Luensmann Off-Site Water Main Extension (Phase I) Project

Job No.: 23-1043

ADDENDUM 2

Date: November 22, 2023

PLAT NO.	
JOB NO.	12473-09
DATE	MARCH 2023
DESIGNER	CD
CHECKED	MP DRAWN CD
SHEET	C3.02

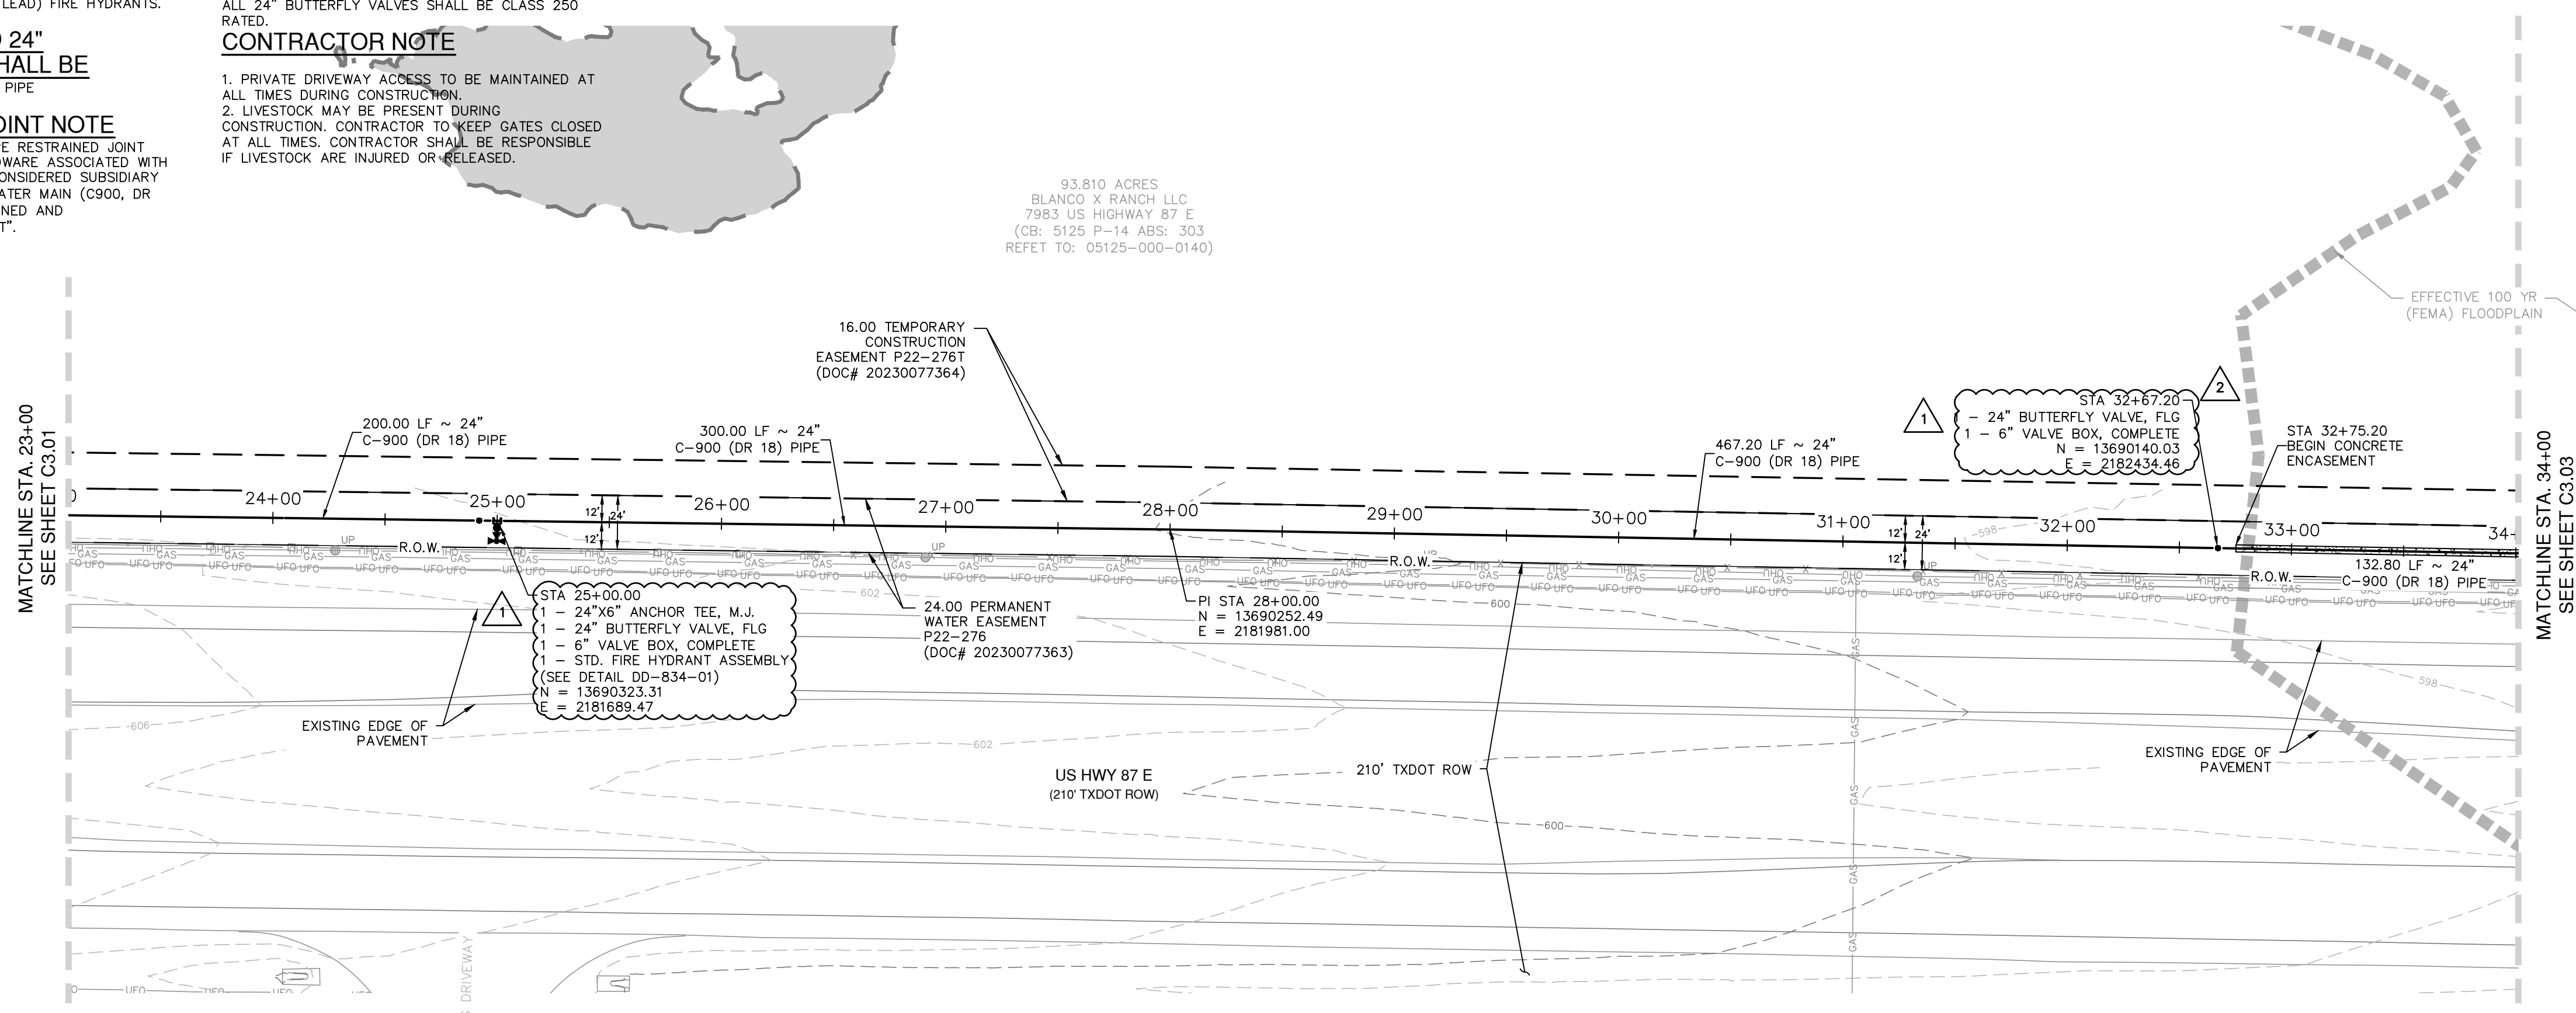
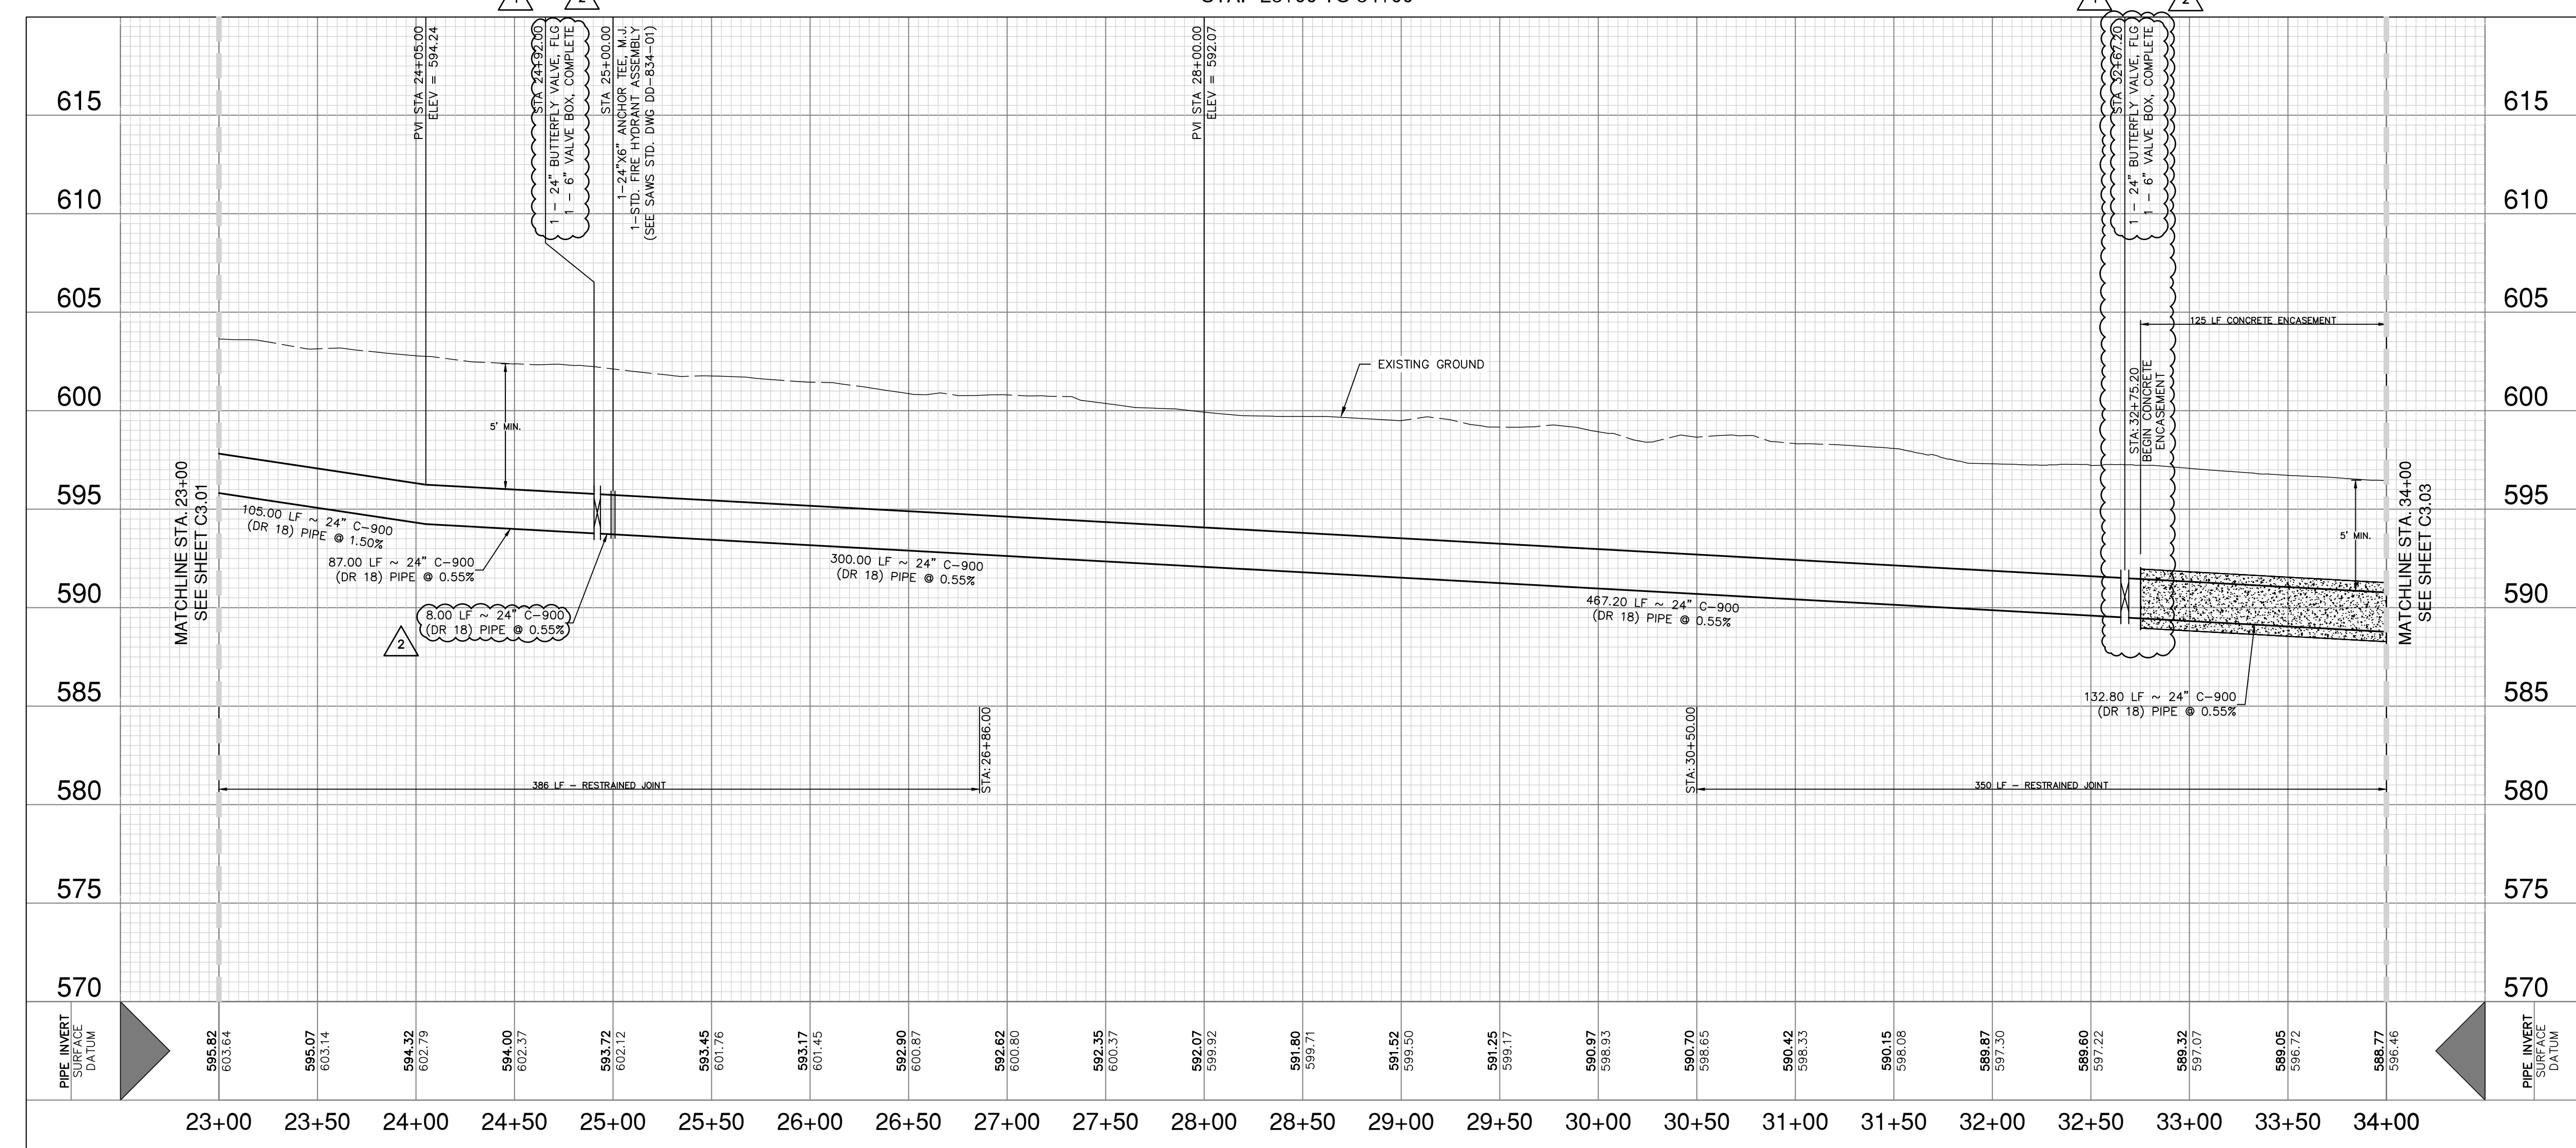
- 2. Question:** Flanged butterfly valves were called for in Addendum 1. How will these be connected per SAWS details? None of these methods are going to work with the amount of pipe going in between the valve and the MJ fittings. Typically all underground valves are MJ connection and above ground or valves in a vault are supposed to be flanged. Can you please clarify or provide a new detail on how you are wanting the connection to the butterfly valves?

1. **Remove** sheets C3.00 through C3.07 in their entirety and **replace** with the versions included in this addendum.

Response: See Changes to the Plans #1. The butterfly valve locations have been revised to allow for installation following SAWS specifications.
